RE: INTERIM AUDIT ADVICE LETTER NO. 2 - REVIEW OF RAP ADDENDUM, SYDNEY MODERN

As a NSW Environment Protection Authority (EPA) accredited Contaminated Sites Auditor, I am conducting an Audit in relation to the Art Gallery of NSW Expansion - Sydney Modern Project building located at Art Gallery Road, The Domain, Sydney.

Conditions identified during recent construction works have necessitated changes to the remedial strategy proposed in the RAP. Coffey prepared 'Remediation Action Plan - Addendum 1, Sydney Modern Development, Art Gallery Road, Sydney NSW' (the RAP Addendum) dated 5 May 2020 to document an alternate remediation strategy for the site.

client:	RICHARD CROOKES CONSTRUCTIONS		
project:	SYDNEY MODERN PROJECT WOOLLOOMOOLOO, NSW		
title:	COVER LAYER - NORTH TANK AREA		
project no:	754-SYDGE234348-EH	figure no:	FIGURE 3
rev:	A

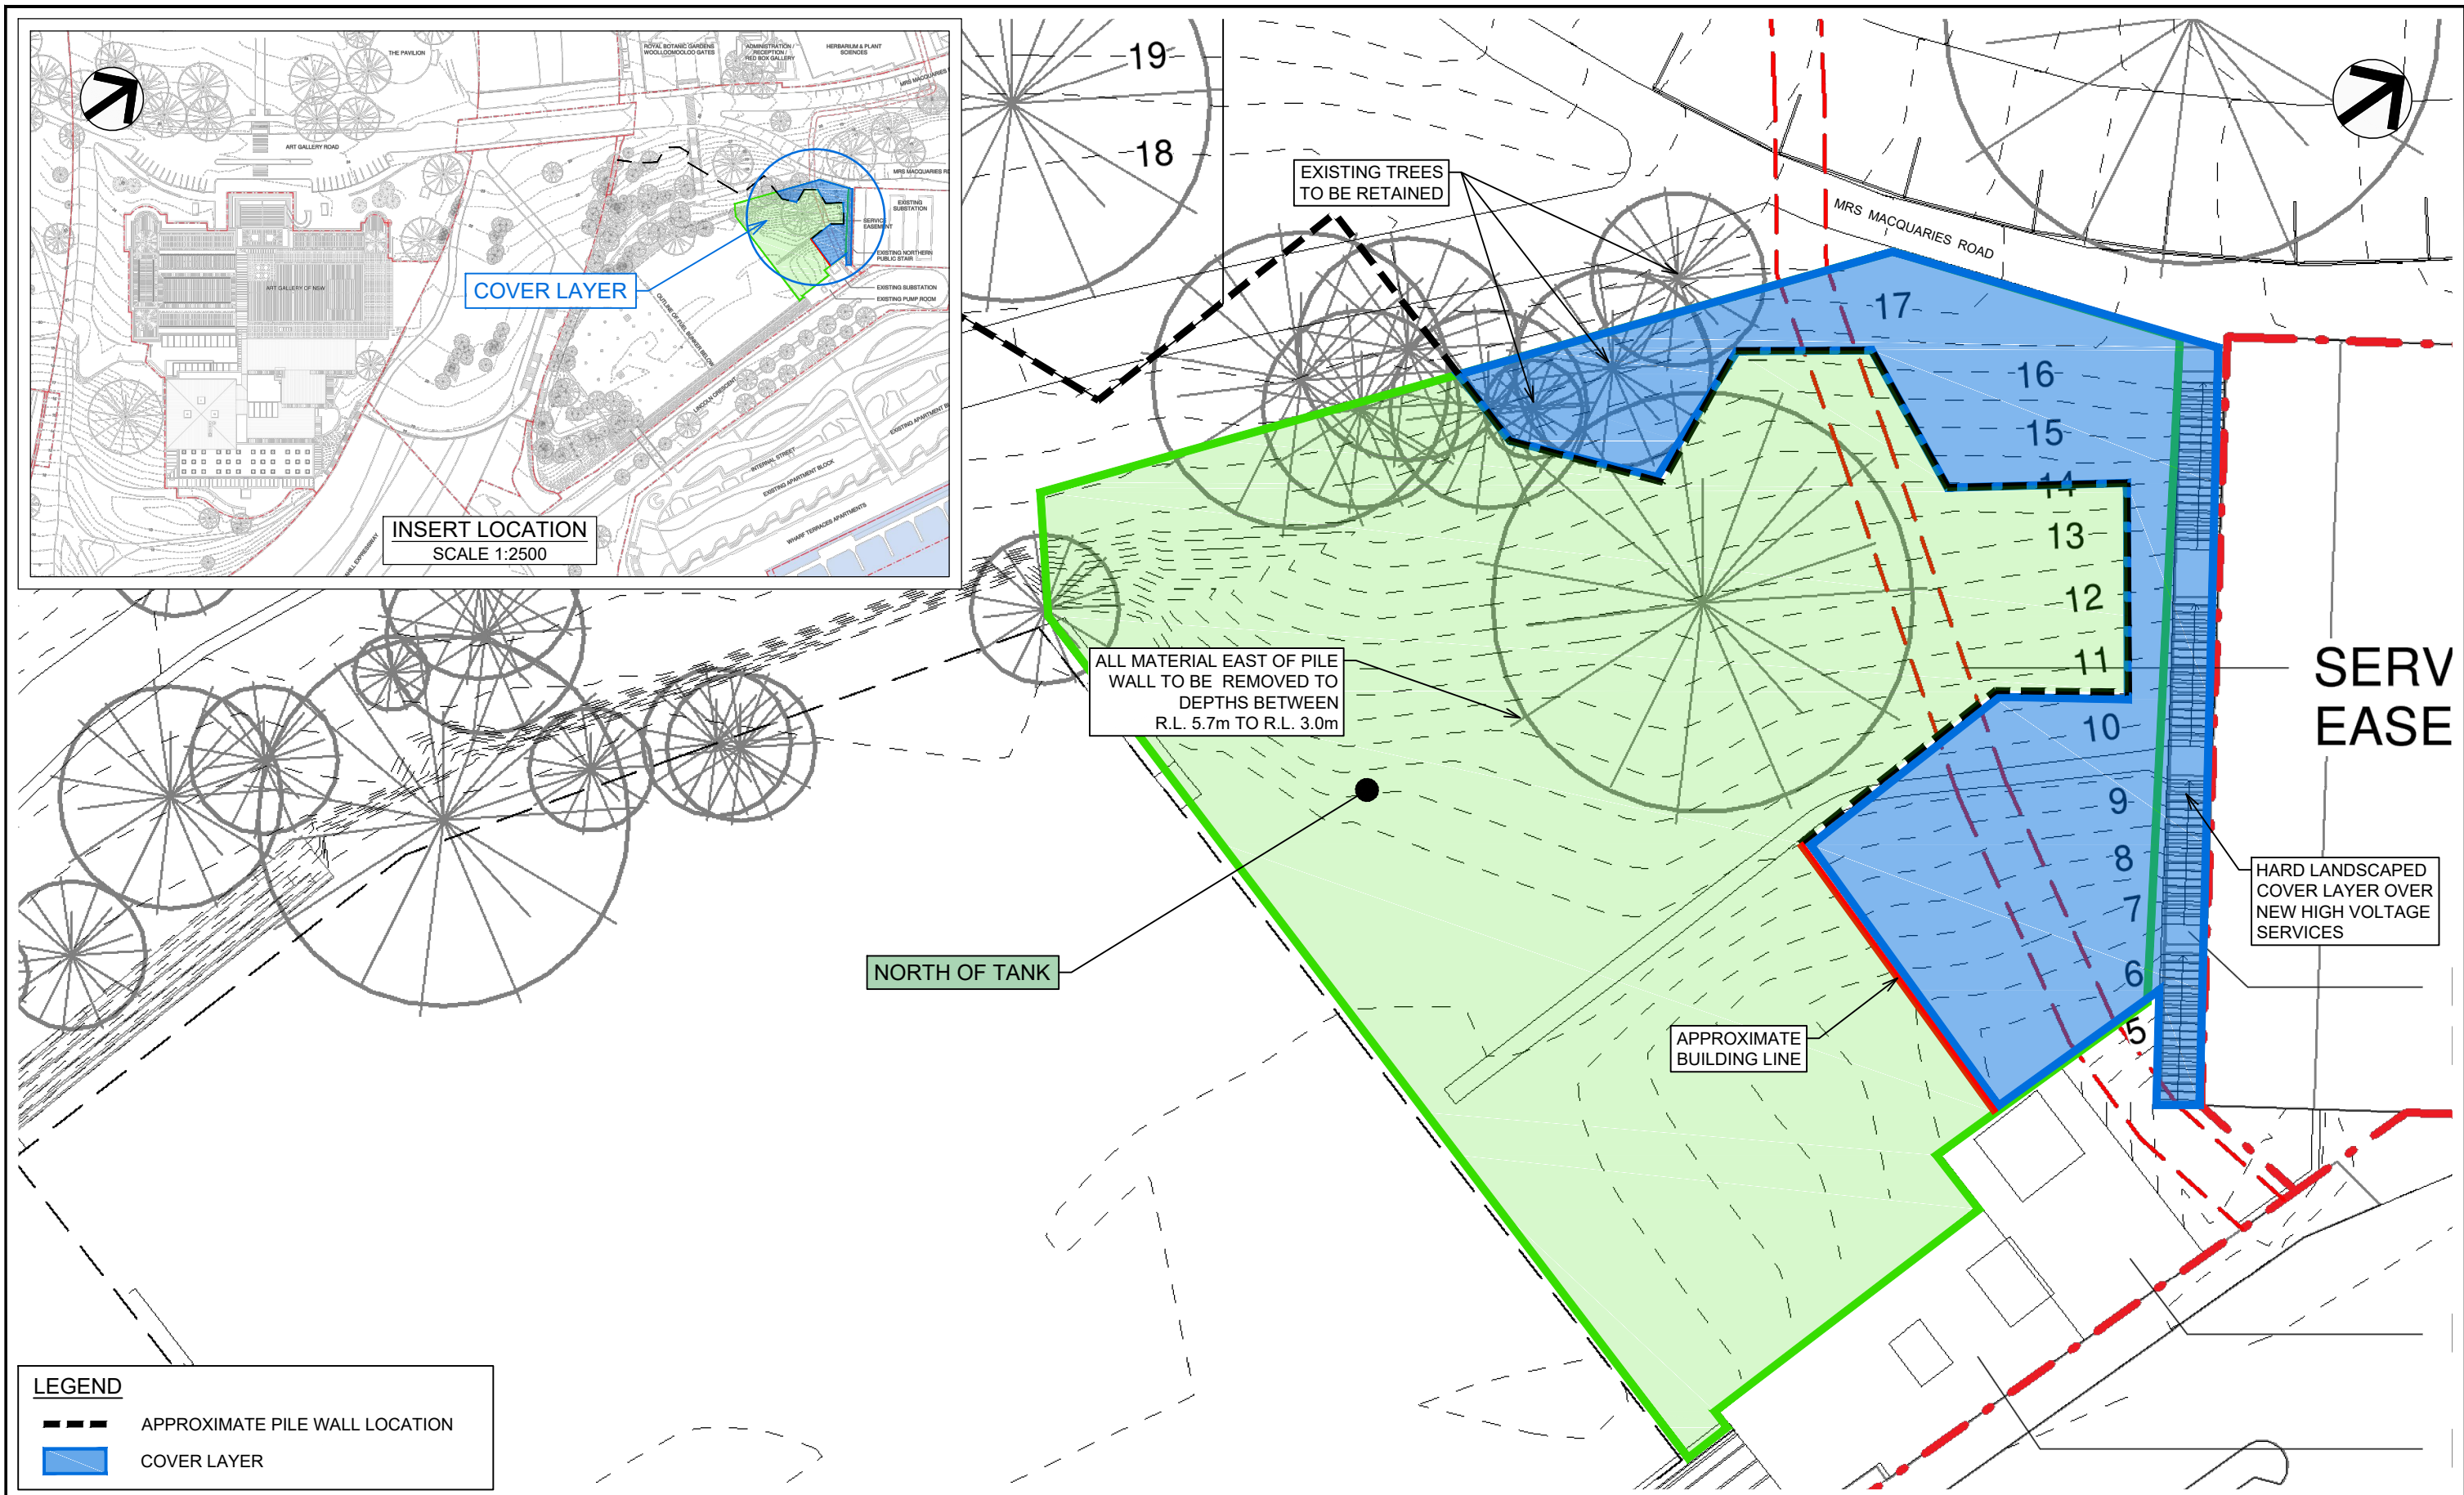
the RAP (i.e. excavation and offsite disposal) due to a high voltage (HV) electrical cable and tree protection zone. Fill material impacted by polycyclic aromatic hydrocarbons (PAHs) and fragments of asbestos cement material (ACM) in this area is to remain in situ with a capping layer placed on top. Some detailed excavation may be required to achieve site levels. The extent of the cover areas is shown in Attachments 2 (Western Wedge) and 3 (North of Tank).
